TO: Development Review Board
FROM: Scott Gustin *SG*
DATE: August 6, 2013
RE: 13-1186CA; 81-83 Adams Street

Request: Convert existing triplex to fourplex by splitting one unit into two. New parking area at rear. Two space parking waiver requested.

Staff measurements at 81-83 Adams Street based on September 25, 2013 site visit:

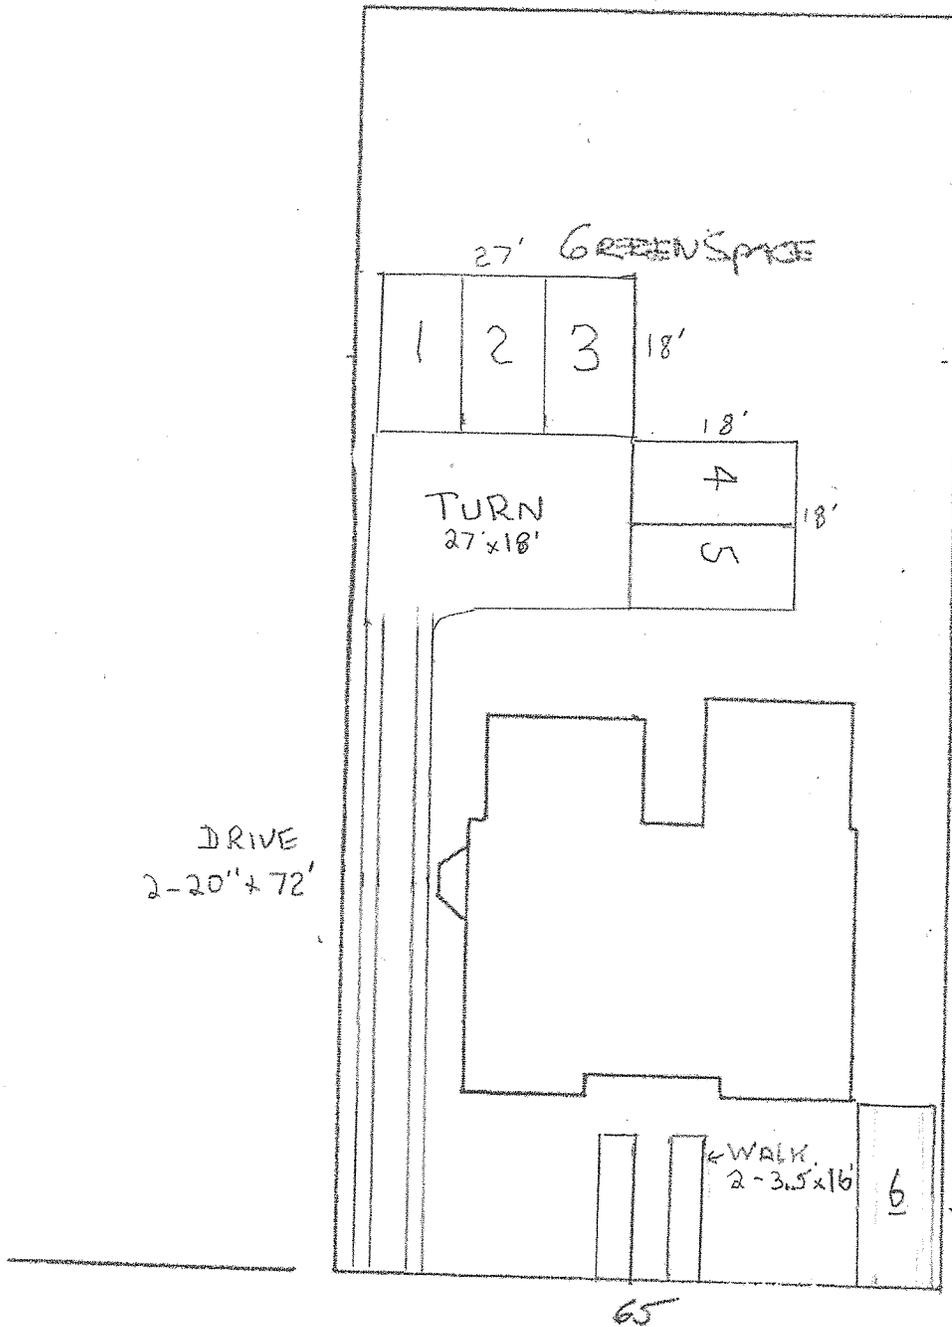
House footprint	1,252 sf
Rear addition 1	204 sf
Rear addition 2	255 sf
Walkways	112 sf
Driveway strips	240 sf
Parking spaces	970 sf
Circulation	486 sf
Total	3,519 sf (38.7% of 9,100 sf lot)
Porches & deck	352 sf
Total with porches & deck	3,871 sf (42.5% of 9,100 sf lot)

F & M PROPERTIES
81-83 ADAMS ST.
1" = 20'

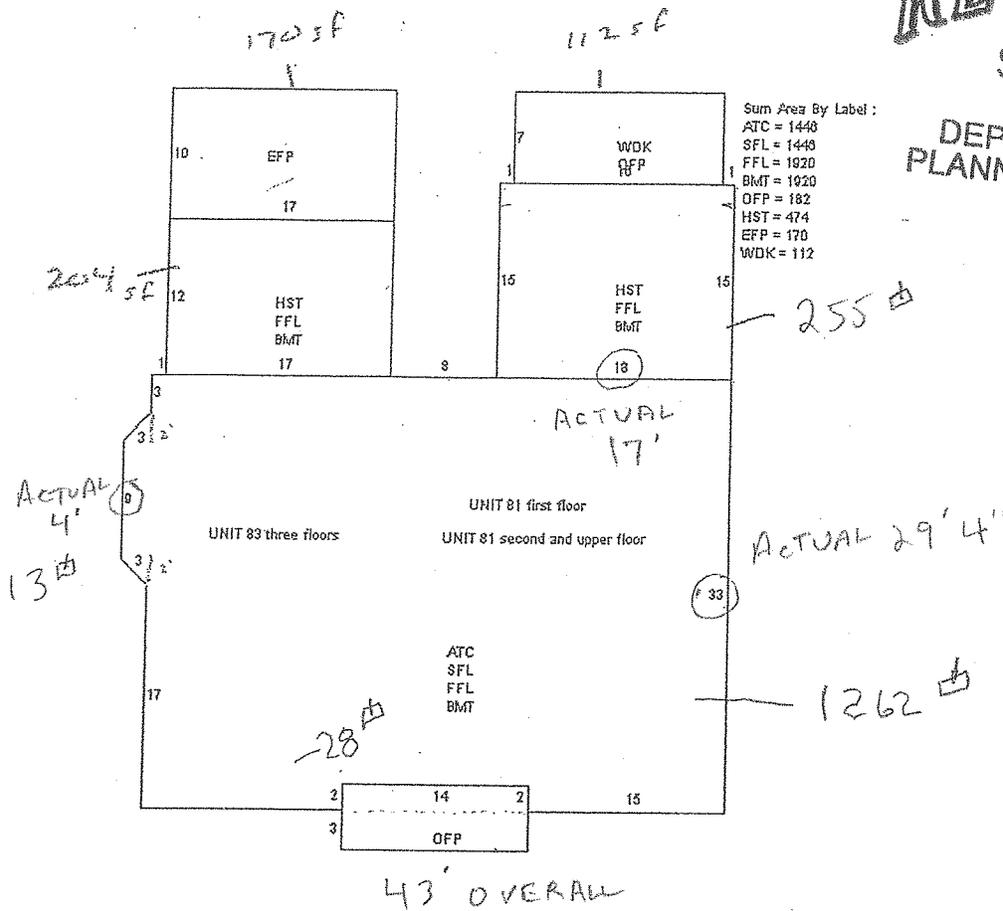
Having reviewed the parking plan and lot coverage calculations for the deadlocked Adams Street application, it appears that even the 6 spaces proposed on site cannot be provided without violating the 40% lot coverage limitation. Thus I propose that we deny the application on this basis and avoid a “deemed approved” application.

Parking Spaces	1080	(6 @ 9X20 as required by Table 8.1.11-1) Space #6 as proposed is front yard parking and calculated at just 66 sq.ft., but parking spaces even when configured as strips do not qualify as green space in part.
Turn Around	648	(27X24 since 24’ is minimum back up required by Table 8.1.11-1)
Walk	112	
Drive	240	(With 20 inch strips – Strips typically range from 24 to 32 inches)
Total	4446	
Lot	9100	
Coverage	48.8%
